NOV_SCE_ATJ_ 20211130-01

NOTICE OF VIOLATION

Energy Safety Inspection Report

Report Name: ATJ_SCE_20211130-01

Structure ID: 4157910E

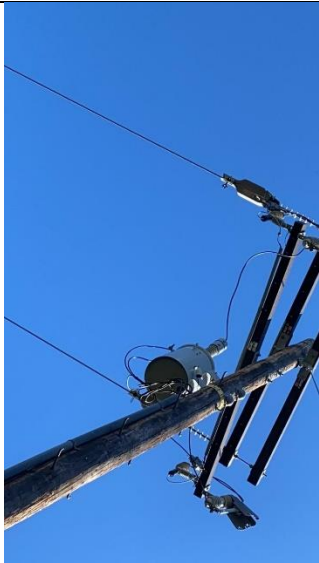
Item12IA1Img1: Vibration dampers not installed

Item12IA2Img1: No fiberglass down guy wire insulator installed
